CONTRACT

Letting Date: February 17, 2015 Contract ID: 78-0293-102 Bid Order No.: 306
County: POTTAWATTAMIE Project Engineer: COUNCIL BLUFFS RCE
Cost Center: 601000 Object Code: 890 DBE Commitment \$2,365,826.80
Contract Work Type: GRADING

This agreement made and entered by and between the IOWA DEPARTMENT OF TRANSPORTATION,
CONTRACTING AUTHORITY, AND
AMES CONSTRUCTION, INC. OF BURNSVILLE, MN, (AM193), CONTRACTOR

Replace plan sheets C.5 & C.6 for IM-NHS-029-3(102)48--03-78 with the attached sheets:

Add New Sheet U.76 for Wabash Trace Nature Trail Foreslope Armoring

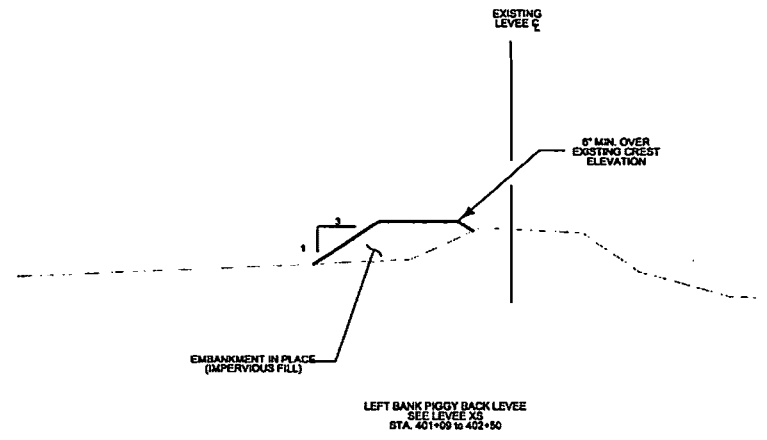
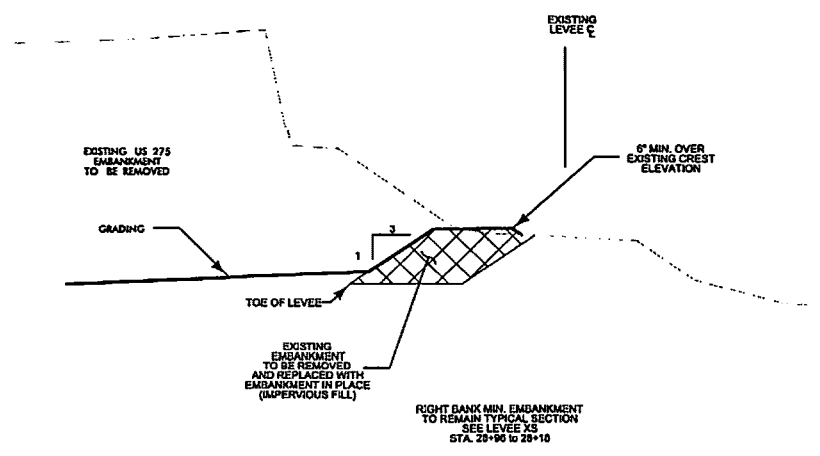
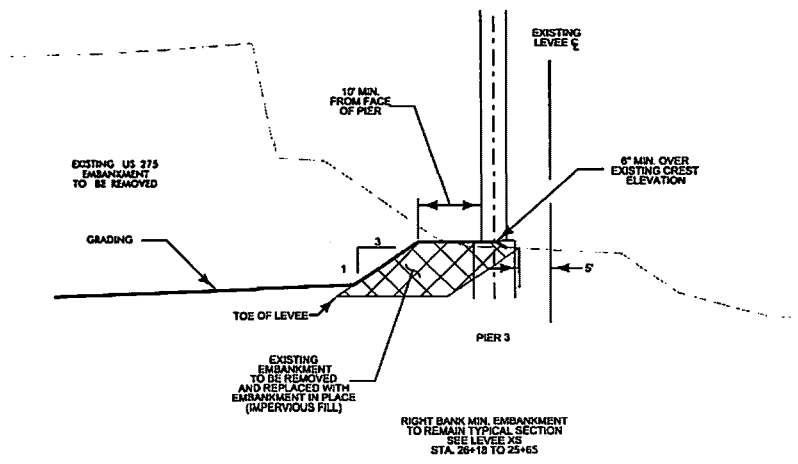
Add Proposal Line No. 1512: 2599-9999018 ('SQUARE YARDS' ITEM) ARTICULATED CONCRETE BLOCK EROSION CONTROL SYSTEM; 1,030.000 SY
Estimate Reference Note: See Sheet U.76 for location and details.

Add Proposal Line No. 1513: 2601-2643413 TURF REINFORCEMENT MAT, TYPE 3 ;
60.200 SQ
Estimate Reference Note: See Sheet U. 76 for location and details

Add "and Pier 6" to notes regarding Piggy Back Levees.
At end of Notes, Stage 5, Add " and install scour mitigation per Sheet U.76."

East Levee under IA 92

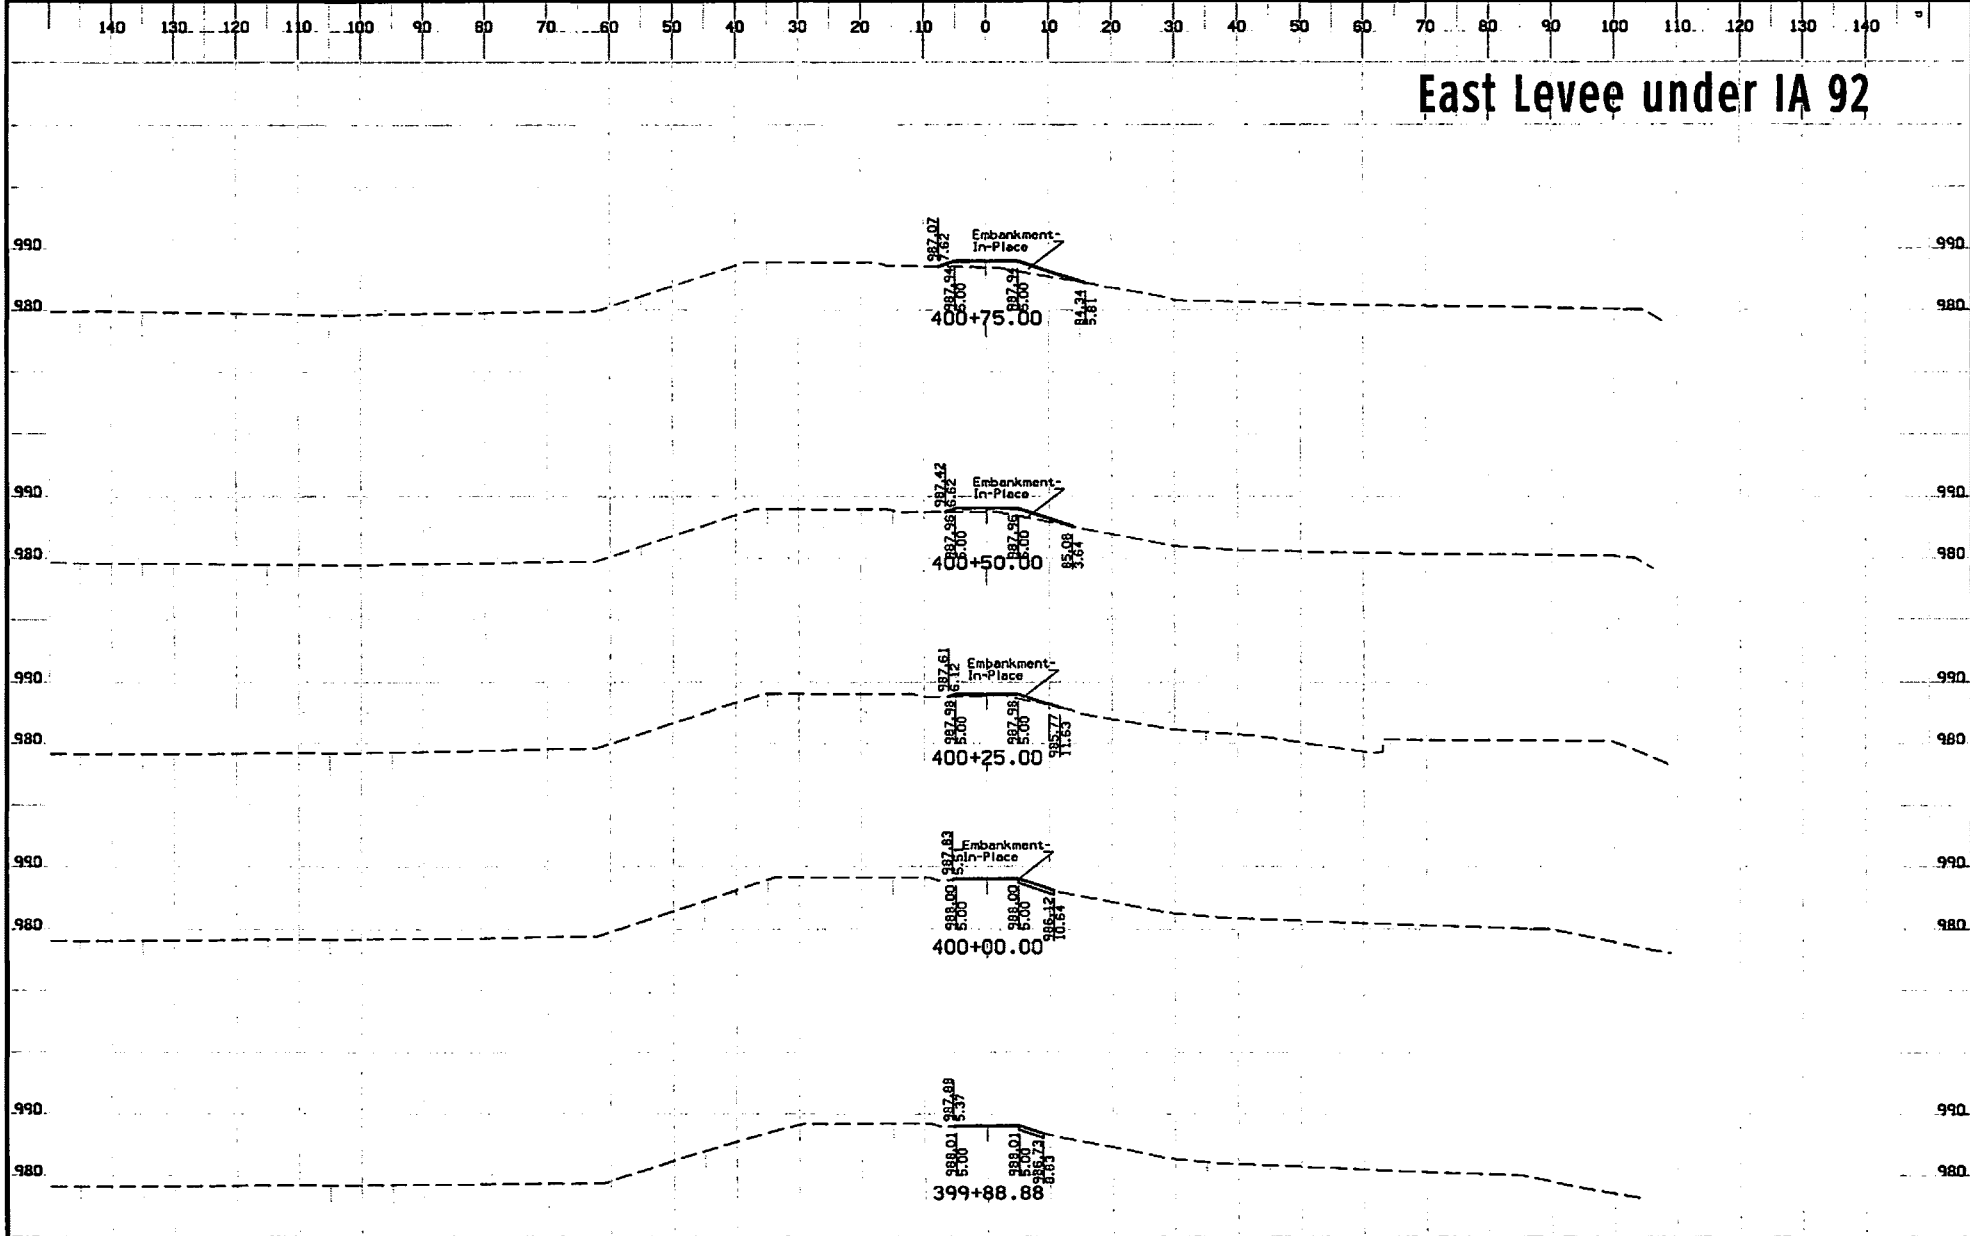
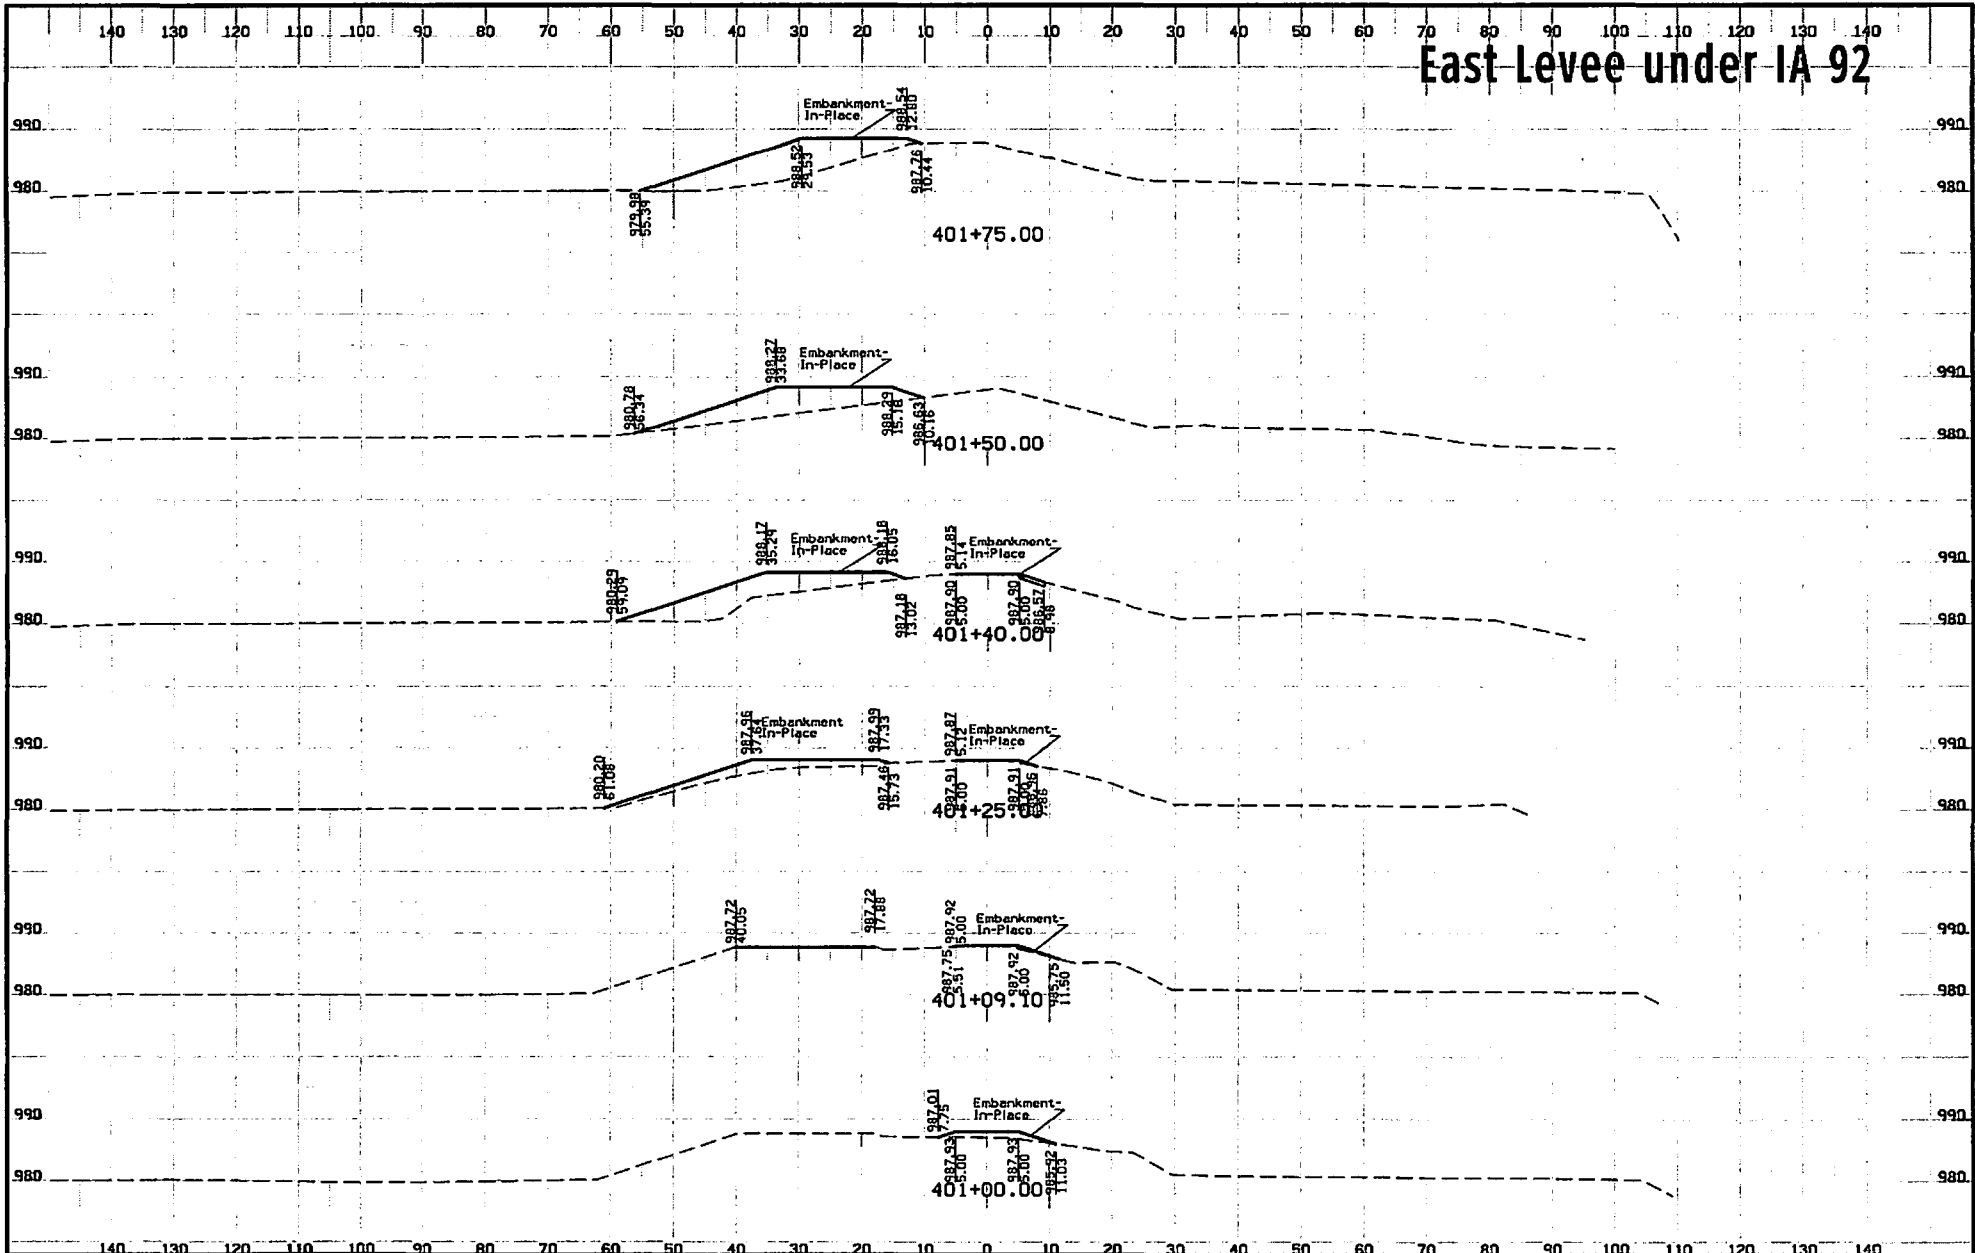
Replace Sheets T.6 and T.7 with the attached T.6 & T.7
New Earthwork numbers for West Levee Under IA 92 RMV Spoil Bank and West Lev and East Levee for extensions of Piggy Back Levees.

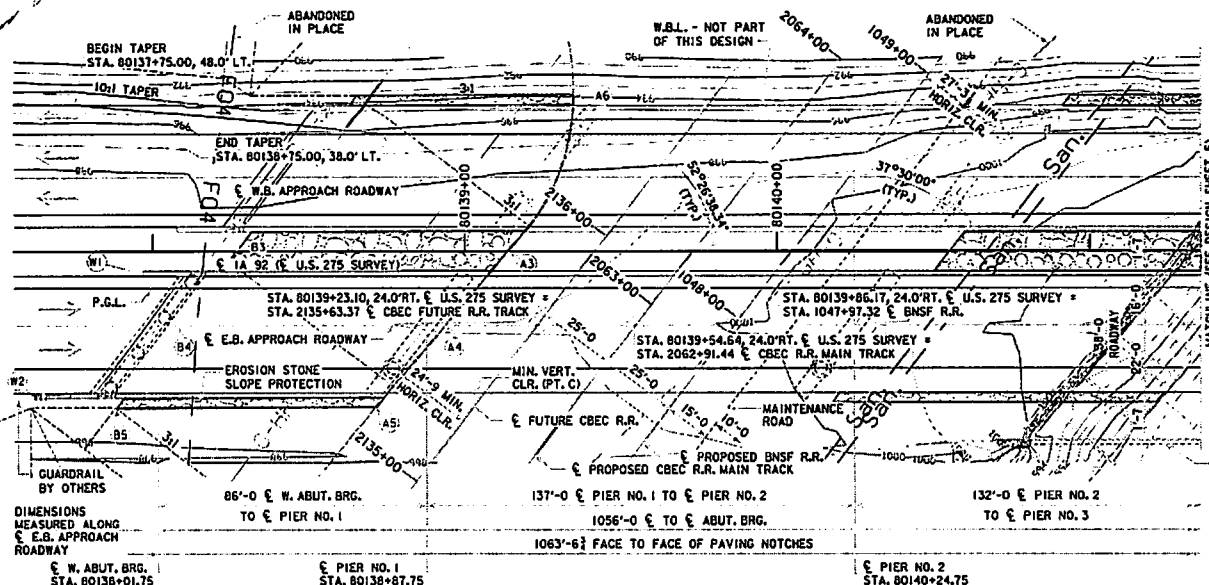
Replace Sheet 97 with attached Sheet 97.

Revised Working Pads to accommodate the piggyback extension. Revised Working Pad Notes.

SITUATION PLAN

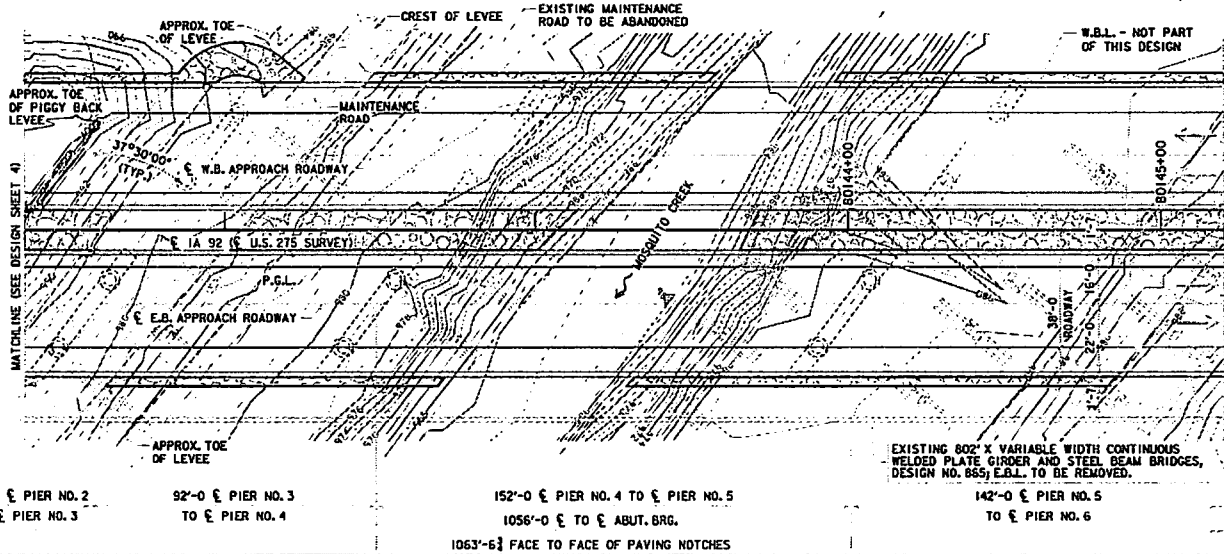
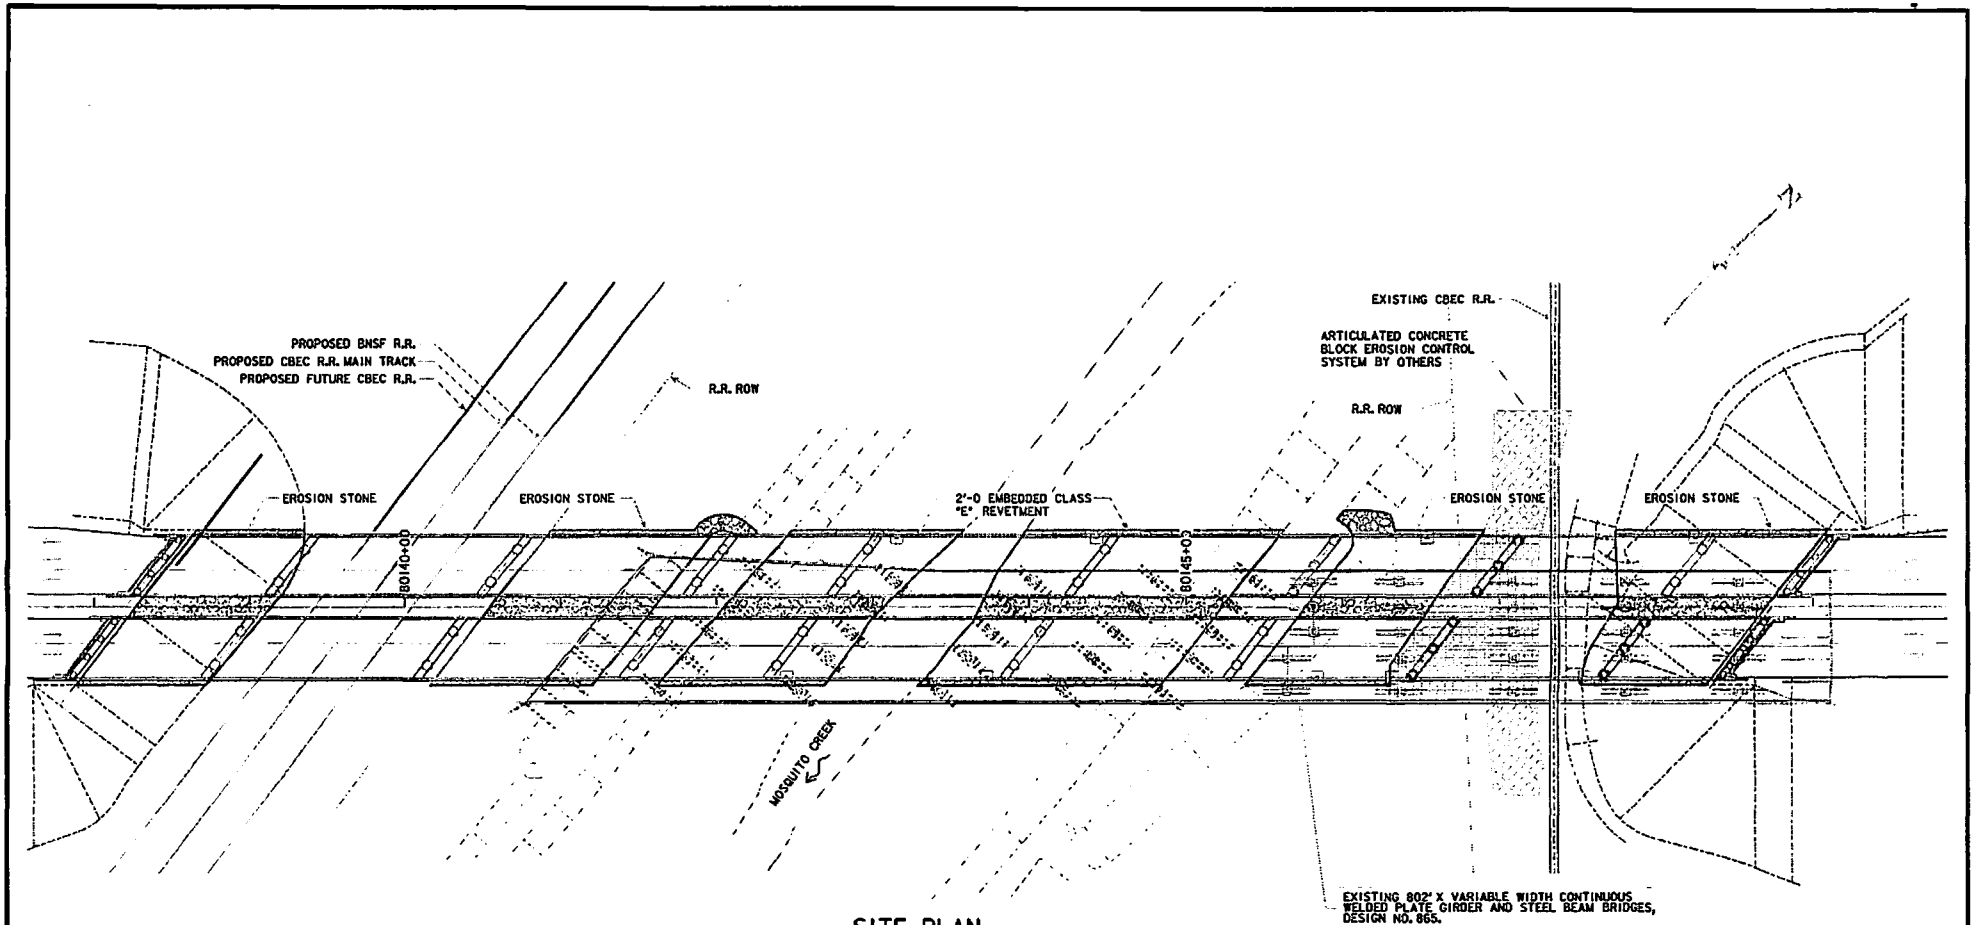
Replace Sheet 6 with attached Sheet 6.

Changes were made to show the piggyback extensions adjacent to Piers 3 and 6. Note was added to reflect that hydraulic data shown does not account for the Temporary Working Pads shown on Sheet 97. This sheet has been resealed for Hydraulic Design.

THE HYDRAULIC DATA ON THIS SHEET DOES NOT ACCOUNT FOR THE TEMPORARY WORKING PADS ON SHEET 97.
